Re: Eagle Cleaners Work Plan Addendum, WDNR BRRTS #02-64-269753

Re: Eagle Cleaners, WDNR BRRTS #02-64-269753 Work Plan Addendum

Enclosure (Proposed Boring Locations Map)

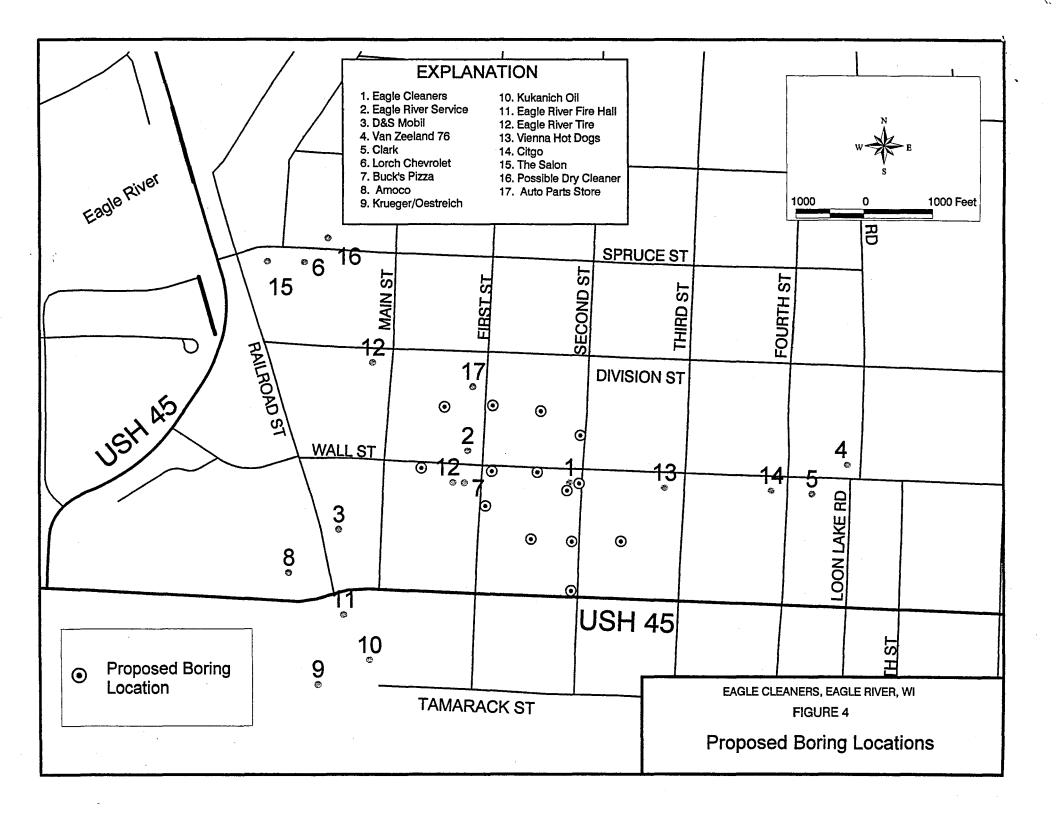
Your comments regarding the tighter grid spacing of GeoprobeTM borings near Eagle Cleaners and locating a probe west of Don's Standard have been addressed by repositioning the proposed boring locations. The new boring location map is enclosed. Of course, the actual locations of specific borings may change depending on the field laboratory results or obstructions encountered during the GeoprobeTM investigation.

ECCI will also locate a boring near the northeast corner of the building to investigate the possibility that solvents may have reached the soil through leaks in the sanitary sewer lateral. ECCI will collect a soil and groundwater sample beneath the floor of the building in the area where the perchloroethylene washing machine and storage tank were formerly housed.

proposed borings.jpg

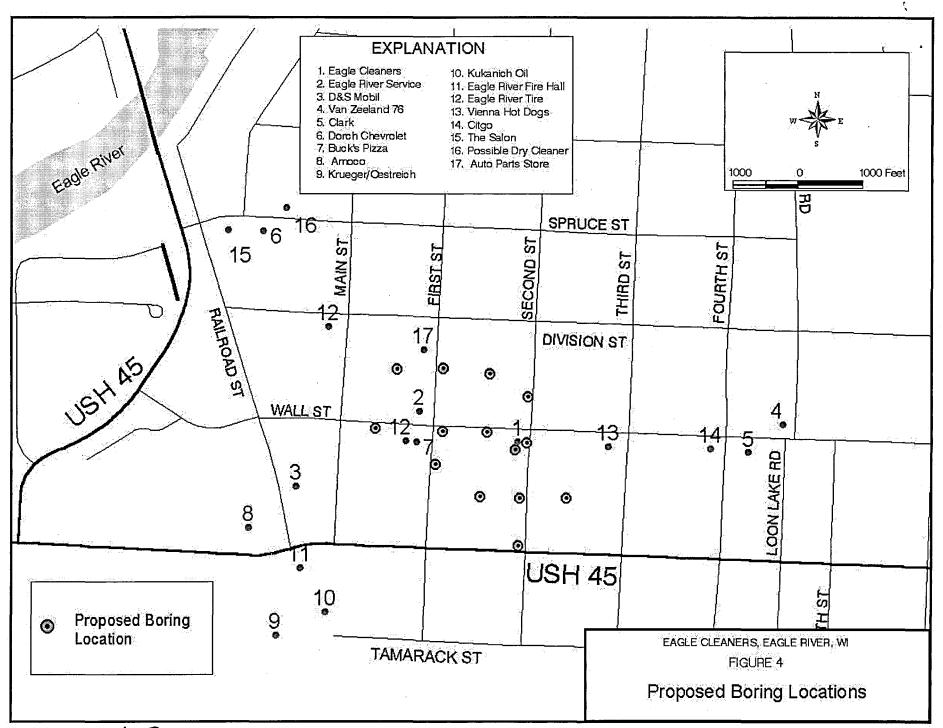
Your comment regarding the tighter grid spacing of Geoprobe borings near Eagle Cleaners and locating a probe west of Don's Standard have been addressed by repositioning the proposed boring locations. The new boring location map is enclosed. Of course, the actual locations of specific borings may change depending on the field laboratory results or obstructions encountered during the Geoprobe investigation.

ECCI will also locate a boring near the northeast corner of the building to investigate the possibility that solvents may have reached the soil through leaks in the sanitary sewer lateral. ECCI will collect a soil and groundwater sample from beneath the floor of the building in the area where the perchloroethylene washing machine and storage tank were formerly housed.
